RE: Johnson/PLN210061

Re: Johnson Hal W Jr. & Allison H; File No. PLN210061; May 28, 2025 Monterey County Planning Commission, Agenda Item No. 2.

Re: Response to Peer Review Comments for
Proposed Development at 226 Highway 1
Carmel Highlands, California
Monterey County APN 241-182-003

SUBJECT: RESPONSE TO PEER REVIEW COMMENTS
Proposed Single Family Residence
226 Highway 1, Carmel, California (Previously 244 #3 Highway 1)
APN: 241-182-003-000

PLANTING PLAN

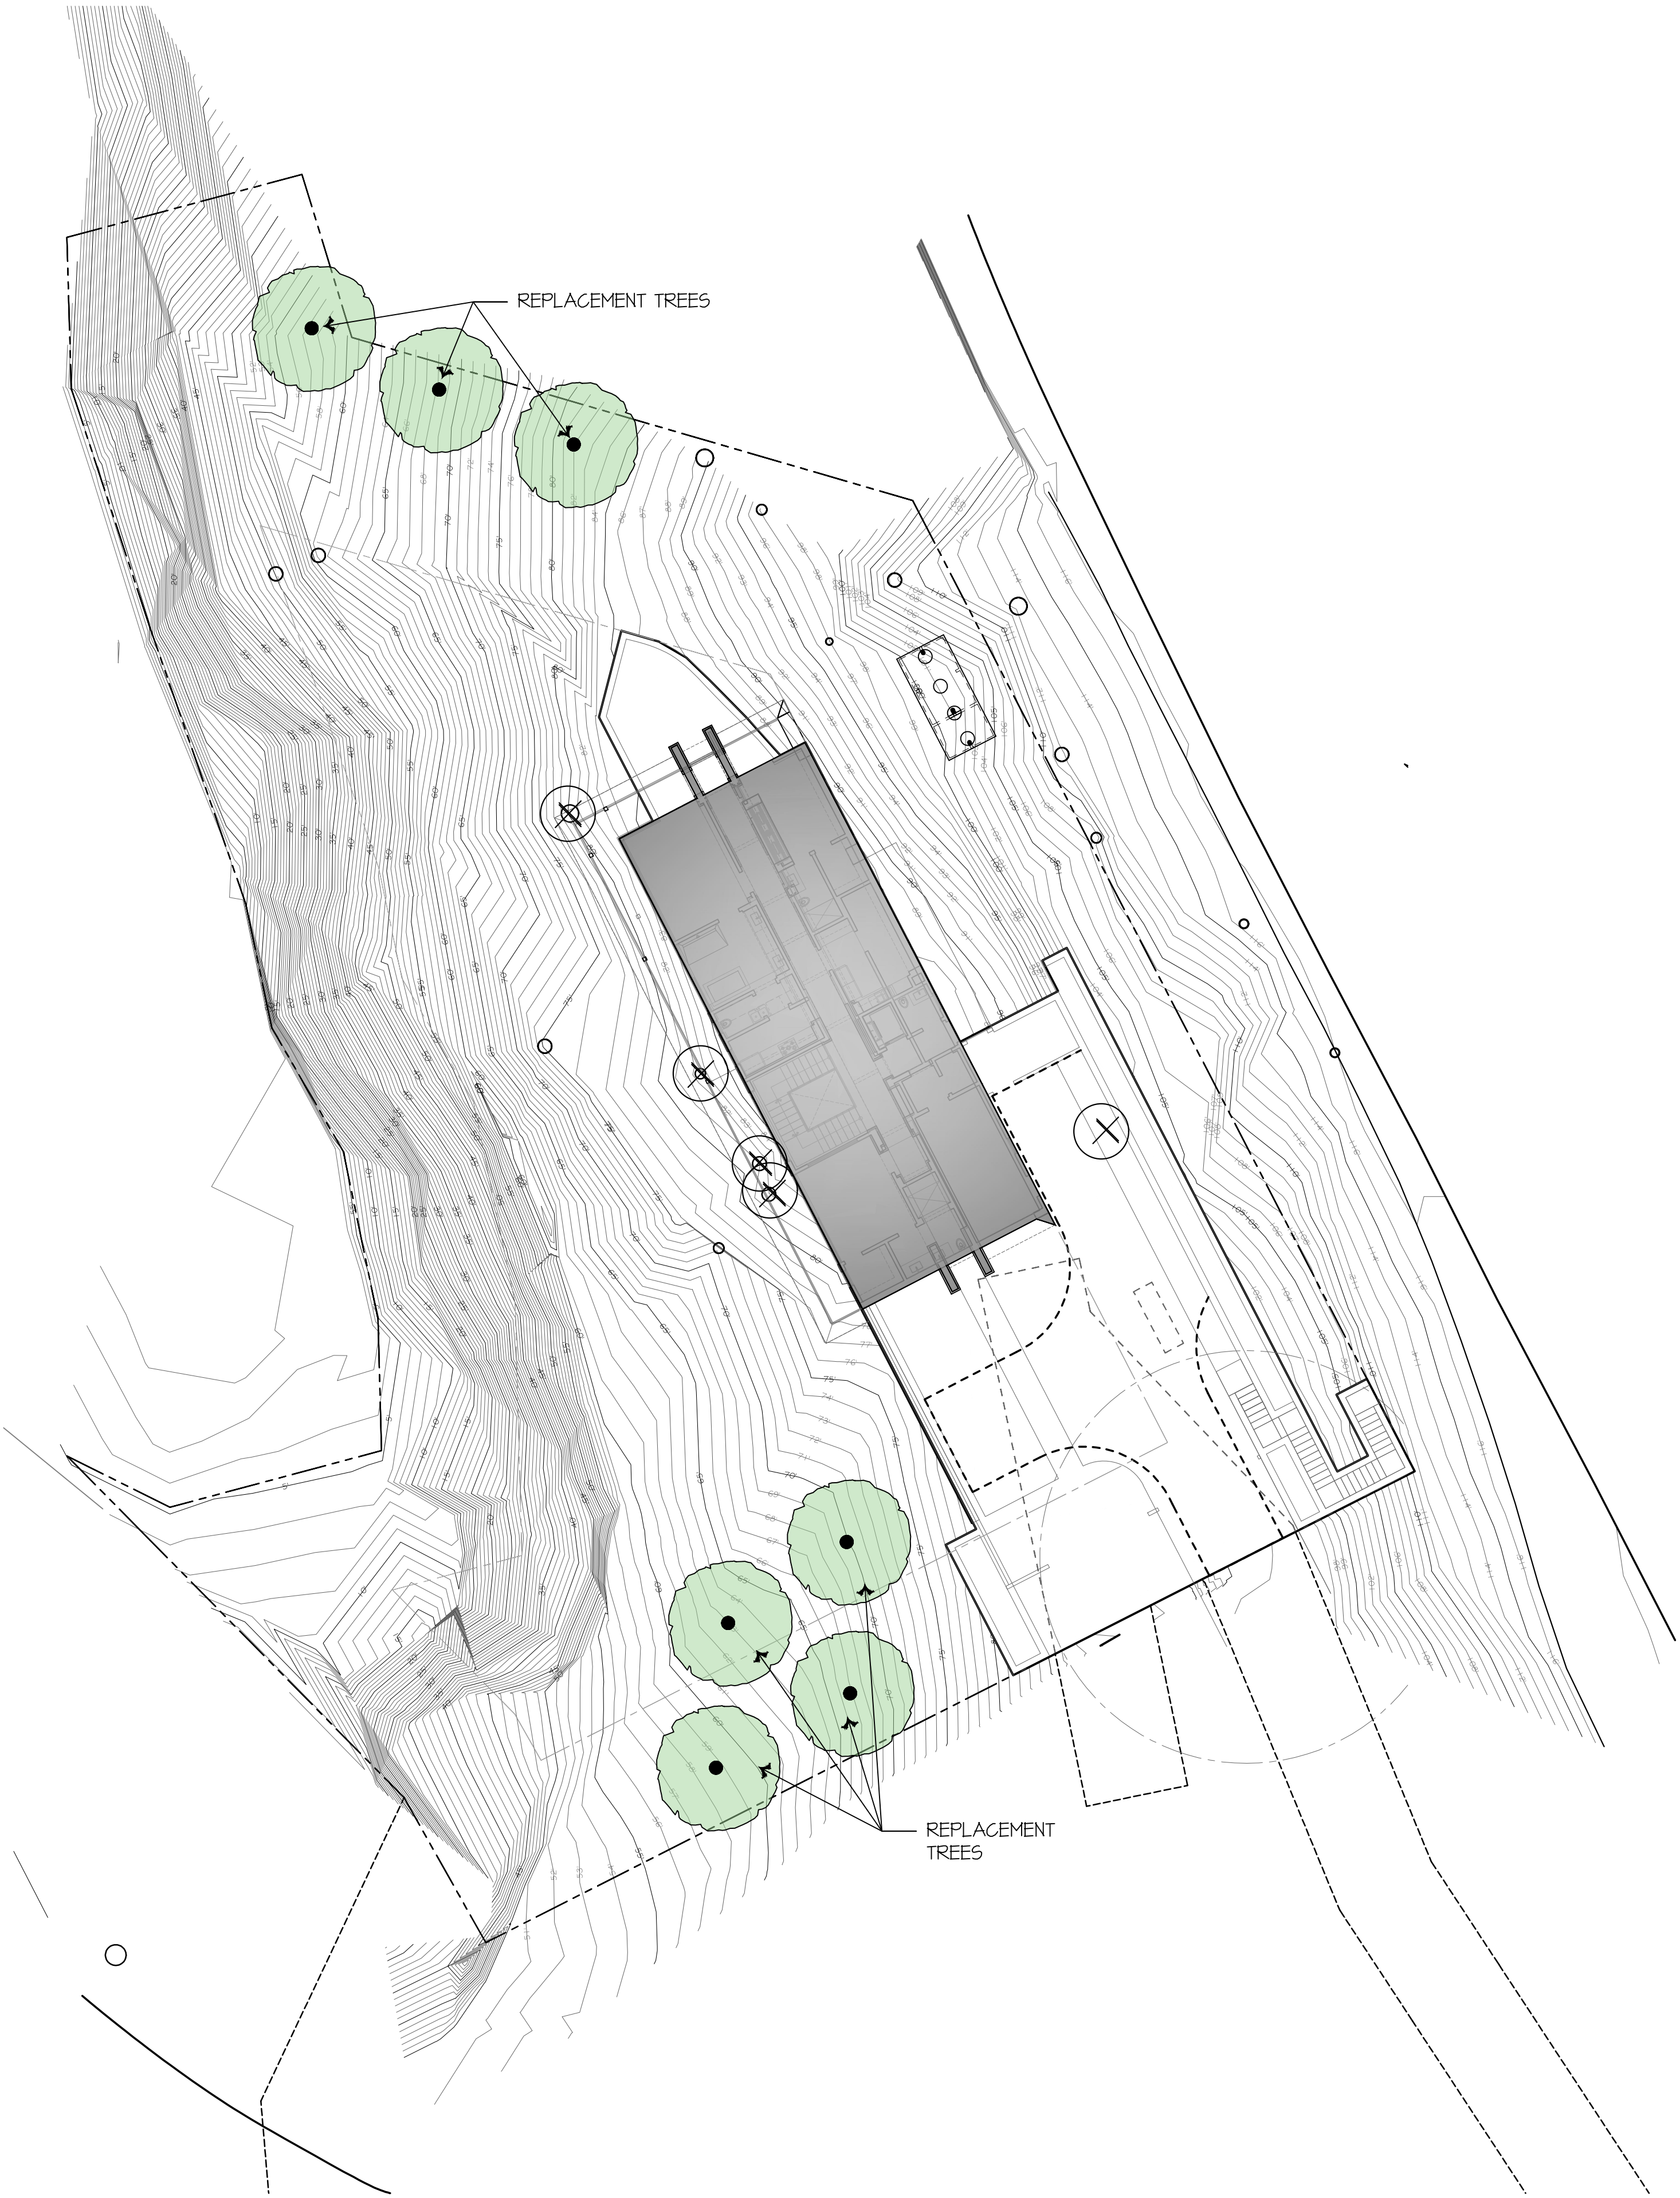
In terms of replacement trees, we had asked the Project applicant to provide a copy of the Landscape Plan shown on Sheet A1.1. The Project plans currently require four replacement trees. Sheet A1.1 showed three replacement trees on the northern elevation of the Project residence. On May 27, 2025 the applicant's attorney provided a copy of the Landscape Plan dated May 23, 2025 that included the three trees along the north plus four new trees on the south that would block coastal views from Owner's residence. (See Exhibit B.) The existing trees proposed for removal do not block such views. We raised these concerns with the applicant's attorney who indicated that the architect may have misunderstood the request and indicated a willingness to work with the Owner on the location of the replacement trees. Along those lines, if the Project were to be approved, we ask that a condition be imposed to require Owner's consent to the location of the replacement trees.

Feature A – A deposit of Qoal.

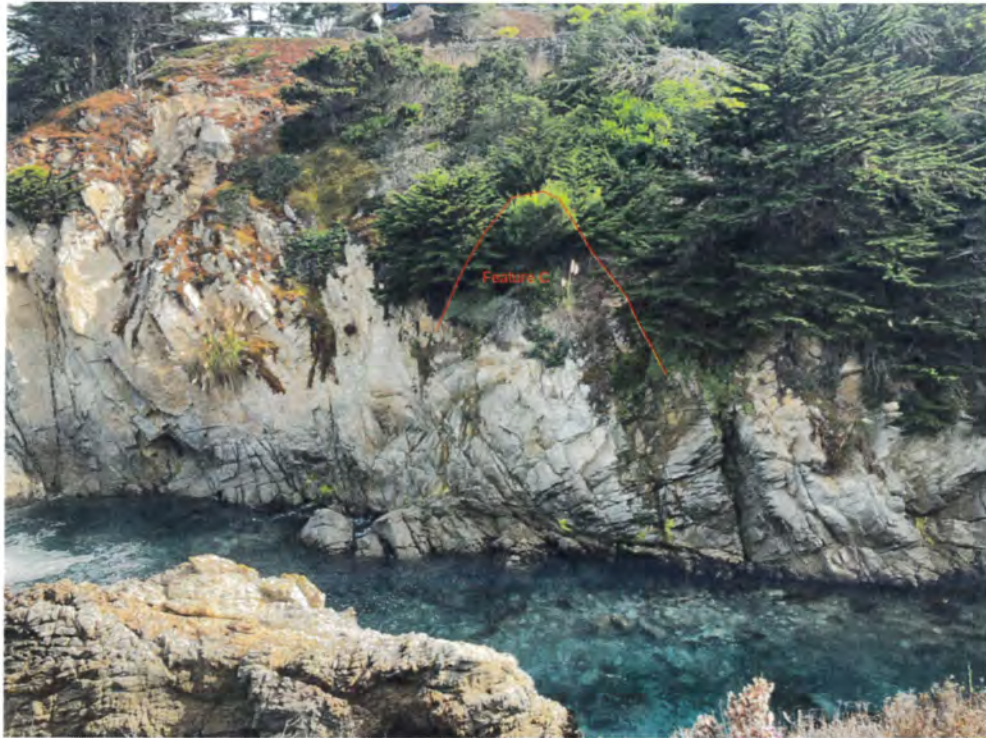
Easton Geology Response: We do not believe that Feature "C", as delineated by the reviewer, corresponds with any mapped slope instability features mapped by our firm. The location of "Feature C" on the photo markup by the reviewer lies in the northernmost portion of the parcel, is coincident with a shallow drainage swale, and appears to be 60 or more feet from any proposed improvements. The joint-bounded headscarp referenced on our geologic map was discussed above and corresponds with Feature "B" delineated by the reviewer.

Figure 5 Project Elevation Profile

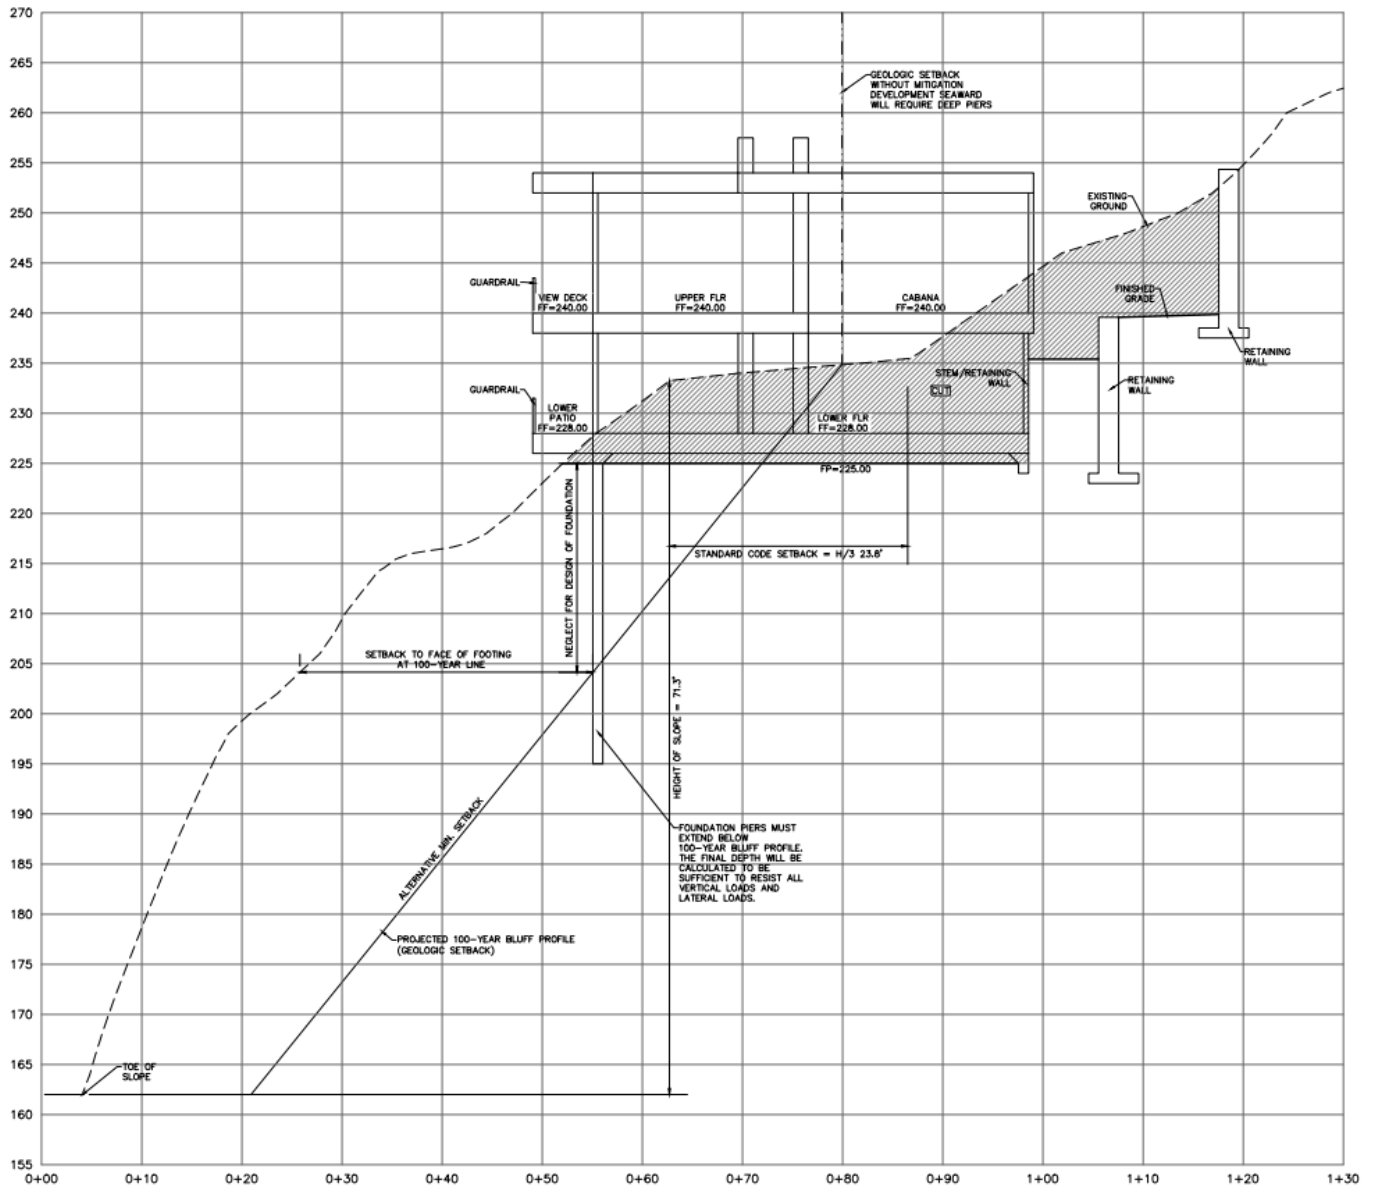
¹ Figure 5 (Project Elevation Profile) of the MND shows how the majority of the Project extends beyond the geologic setback line, protruding over the steep coastal cliff face. A copy of this figure is attached hereto as Exhibit A.
